TOWNSHIP OF McNAB/BRAESIDE COMMITTEE OF ADJUSTMENT AGENDA

Re: Minor Variance Application – Request for Additional Height for Accessory Garage Building

PROPOSED DETACHED GARAGE
130 LORIEL DRIVE

MINOR VARIANCE PLANNING REPORT

BUILDING SECTION X-X

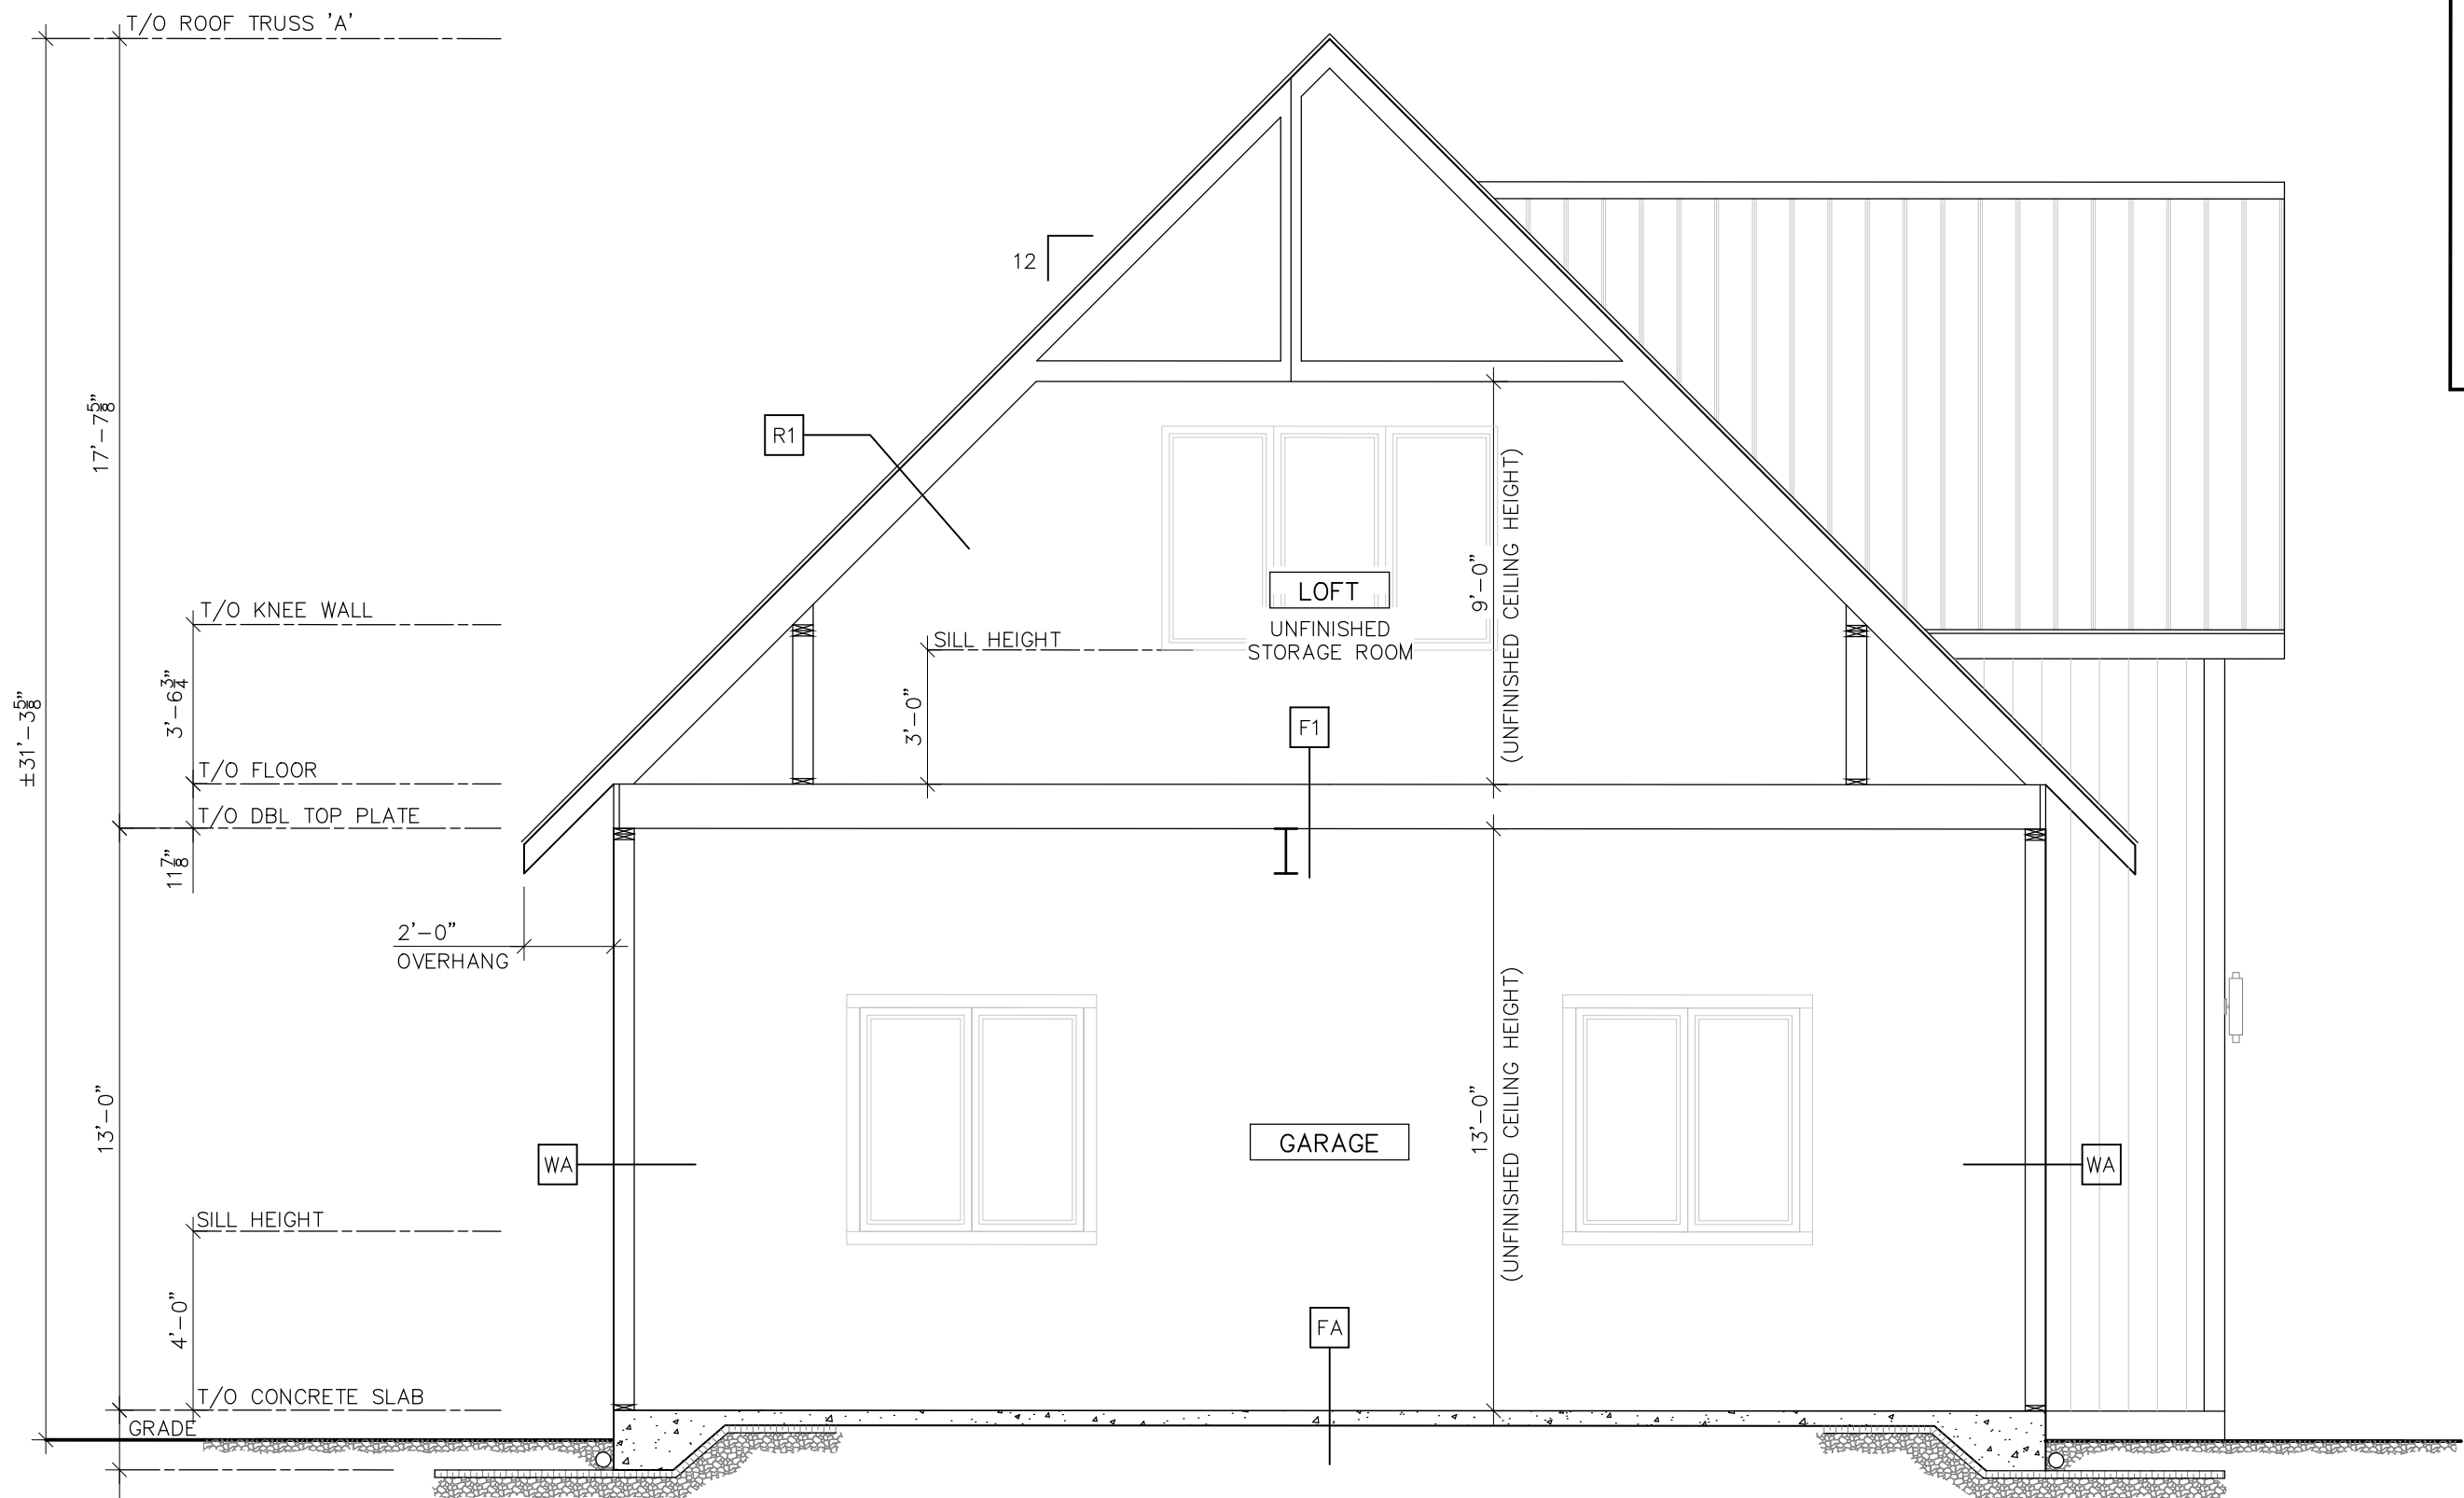
The proposed accessory building is required to meet the applicable requirements of the Rural (RU) Zone and the accessory building requirements of the General Provisions of the Zoning By-law. The building and site layout plans submitted with the application show the proposed location of the new accessory building on the lot and that it meets or exceeds the minimum required setbacks from the front, rear and side lot lines. For the proposed building, the only issue is height, as it exceeds the maximum permissible accessory building height of 5.0 metres, by an additional 1.7 metres.

The accessory building is proposed to serve a dual purpose for secure parking and personal storage. The additional height is being requested to accommodate the storage area and provide ease of access within the storage area. The dual purpose building negates the need for two separate buildings thereby maintaining visual aesthetics for this and neighbouring properties. The accessory building will be located next to the shared property line with 124 Lorlei Drive. The proposed placement of the shed will be visible from that neighbour's dwelling but does not crowd it, nor will it cause shadowing issues. Likewise, the proposed shed will not negatively impact the dwelling at 140 Lorlei Drive, on the south side of the subject lands. There are intervening trees that will provide a partial visual buffer. Trees in the front yard of the subject lot also buffer the view from the road. The proposed building elevations depicts an aesthetically pleasing structure that will blend with the surrounding existing residential development. For these reasons, the variance requested can be considered desirable.
